ALERT Service Bulletin – Product Recall Action – ASB2009/12/23

SL10-531/BTT

Alert SB-Nr.:	ASB2009/12/23
Subject	Product recall of TCR16, TCR18, TCR20, TCR22 turbochargers Improvement of connection of bearing casing and compressor casing
Serial Numbers concerned	all
Reason	<p>During the development of the TCR turbochargers the containment safety of the existing flange connection was thoroughly proven by simulations and tests.</p> <p>Nevertheless operation in field has shown in singular cases a damage of the compressor wheel, which was initiated by foreign object impact. This caused a failure of the flange connection. As a consequence fragments of the compressor wheel could be released.</p> <p>For this reason the design of the flange connection was optimized in order to safeguard the containment safety even under circumstances as described above. This optimization regarding the containment safety of the TCR16, TCR18, TCR20 and TCR22 turbochargers by installation of the modified clamping claws and screws is now specified by MAN Diesel.</p>

Figure 1. previous flange connection

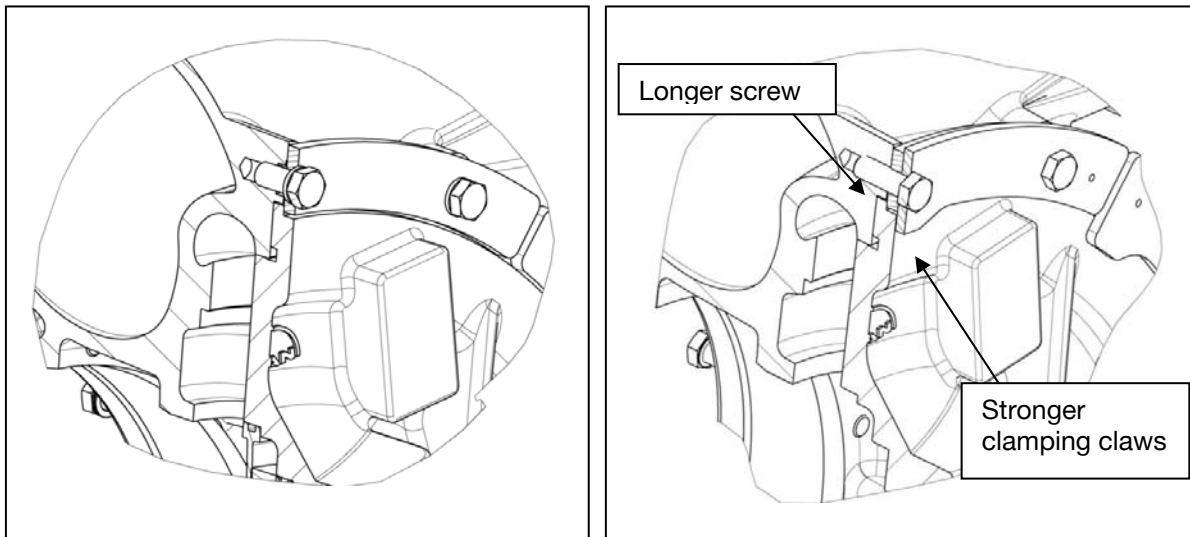
Compliance	Mandatory
Description	<p>The turbocharger must be updated to an improved flange connection. The clamping claws were stiffened by the application of a second layer of claws. The new design has also stronger and longer screws. On the majority of the turbochargers this update can be carried out by the crew during a normal harbour stop. In few cases the update is more extensive and has to be carried out by qualified personnel.</p> <p>In order to exclude all eventualities: As long as the above described conversion has not been carried out we strongly demand to advise the crews on board of the affected vessels not to stay in the engine room as long as the engine operates above 80% load. For all other load profiles no person shall as usual stay unnecessarily in the danger zone of the turbochargers during operation (according to TC manual).</p> <p>After the conversion please refer to the normal safety instructions in your manual.</p>

Figure 1 shows the new design flange connection.

improved flange connection
